# Access Compliance Report

## Public Rights-of-Way

Intersection ID: 29523	Main Street: SEDGEWOOD_CR	Cross Street: SEDGEWOOD_PLACE_CT	Location:	N
ADA ID: E81AE5A07F12	Ramp Type: PerpDiag	Initial Pass/Fail: Fail	Overall Compliance: No	Severity Score: 12.5

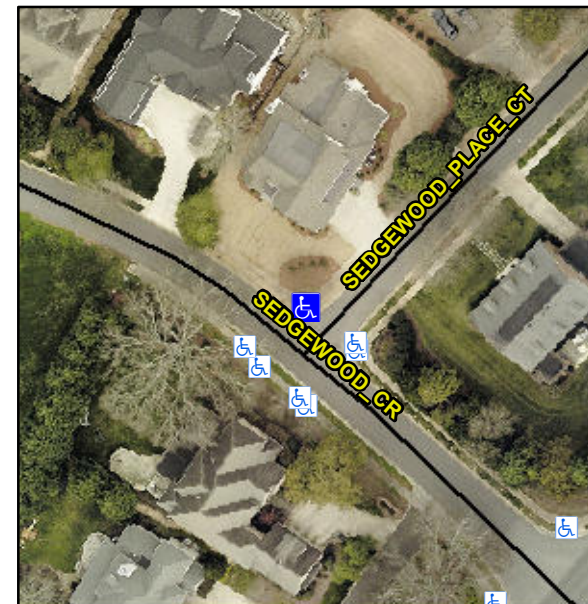
**Not Found, R304.2.2**

Compliance	Description	Data	Compliance	Description	Data
N/A	Ramp Length (in)	49.0	No	Ramp Slope (%)	8.6
Yes	Ramp Width (in)	48.0	Yes	Ramp XSlope (%)	0.2
N/A	Flare Type LT	N/A	N/A	Flare Type RT	N/A
N/A	Flare Slope LT (%)	N/A	N/A	Flare Slope RT (%)	N/A
N/A	Flare Traversable LT?	N/A	N/A	Flare Traversable RT?	N/A
N/A	Landing Length (in)	N/A	N/A	DWS Provided?	N/A
N/A	Landing Width (in)	N/A	N/A	DWS Contrast?	N/A
N/A	Landing Slope (%)	N/A	N/A	DWS Length (in)	N/A
N/A	Landing X Slope (%)	N/A	N/A	DWS Full Width?	N/A
N/A	Landing Curb? (Y/N)	N/A	N/A	DWS Offset (in)	N/A
N/A	Shared Landing?	N/A			
N/A	Gutter Ponding?	N/A	N/A	Gutter Slope (%)	N/A
N/A	Gutter Lip Ht (in)	N/A	N/A	Gutter X Slope (%)	N/A
N/A	Painted X Walk1?	No	N/A	Painted X Walk2?	No
	X Walk 1 Direction	To SW		X Walk 2 Direction	To SE
N/A	X Walk 1 Width (in)	N/A	N/A	X Walk 2 Width (in)	N/A
	X Walk 1 Slope (%)	1.2		X Walk 2 Slope (%)	3.6
	X Walk 1 X Slope (%)	2.2		X Walk 2 X Slope (%)	4.4

**Remove & Replace Curb Ramp With Two New Directional Ramps or Equivalent.**
